Burgos Wind Farm Project

Technical Desk Review

This report presents the findings of the review, commissioned by the World Bank, of a 30MW wind farm in the northern Philippines being developed by PNOC-EDC. The review scope is limited to a desk review of some of the tender documents and the annual energy production estimate made by PNOC-EDC. In general, it is the reviewers' opinion that the documents provide the correct framework for a successful project and sufficient energy analysis for the financial investment. However, a major exception is the specification of the wind turbine itself, which appears to allow a wind turbine that may be inappropriate for the site conditions.

Figure 1 Wind rose and wind-speed histogram of measured data March 2001-February 2002

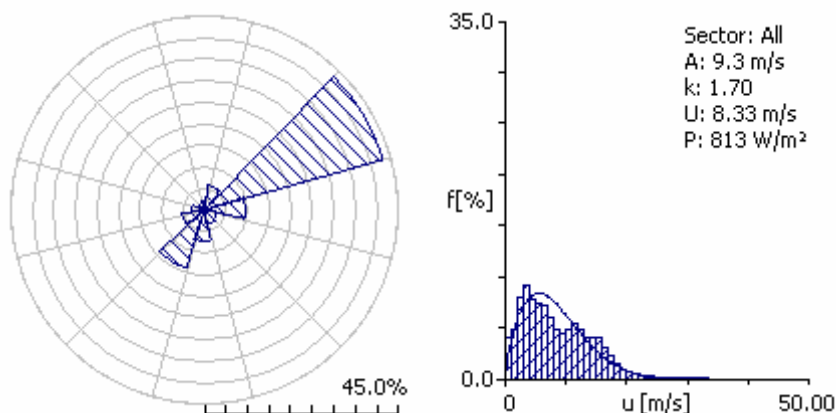
Risø received meteorological measurement from the period Mar01-Feb02 in an MS Excel file [7], where data points with simultaneous zero wind speed and direction had been marked as suspicious. We agree that these data points should be excluded from the analysis and note that the correction only reduces the data recovery rate from 100% to 99.6%, which is still nearly perfect. Unfortunately, even when the

marked data points removed, we are unable to find the same wind distribution as in the PNO-C-EDC feasibility update report suggesting that we are not using exactly the same data. The discrepancies are however modest 0.2% for both average wind speed and wind power density. Our results are shown in Figure 1 and Table 3.

Figure 4 Wind resource map of Gross AEP with directional distributions and wake losses at turbine positions.

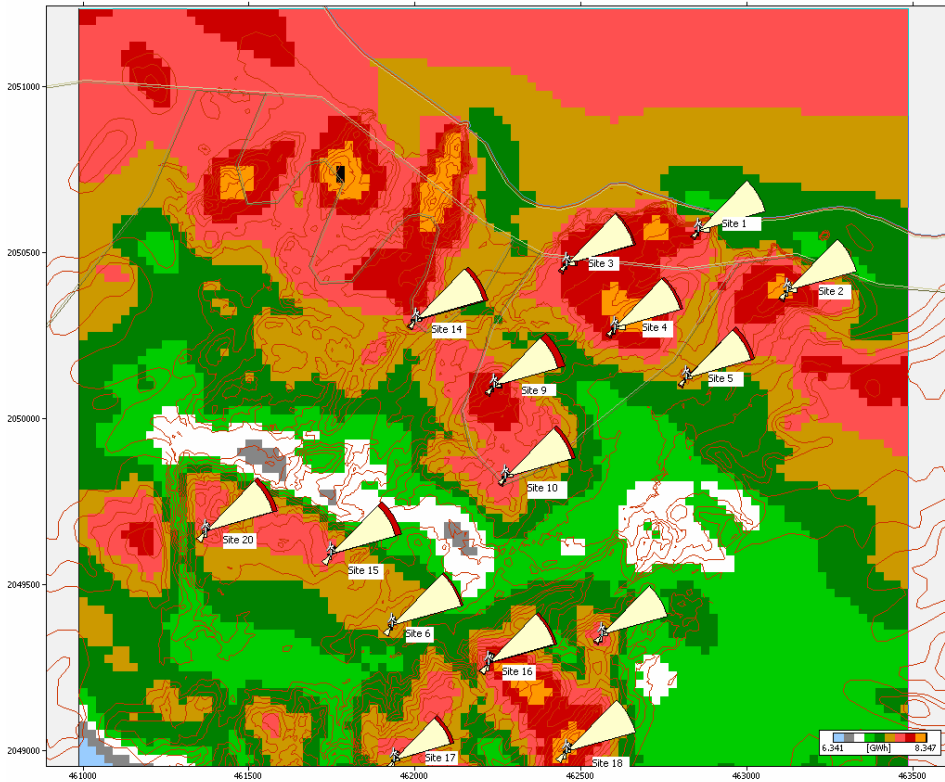
Figure 4 shows a wind resource map of gross AEP for a Vestas V80 2 MW turbine with 67m hub height. Also shown are the directional AEP distributions at the turbine positions with correction for wake losses. The layout is a reasonable compromise between having turbines near local optima in the spatial wind resource distribution and keeping a proper distance between the turbines. Further optimization might be possible, e.g. by moving turbine site 1 westward near a local optimum or moving

turbine 9 backward to reduce its relatively high wake loss. These adjustments will only be fine-tuning since the turbine AEP are not too different, see Figure 5
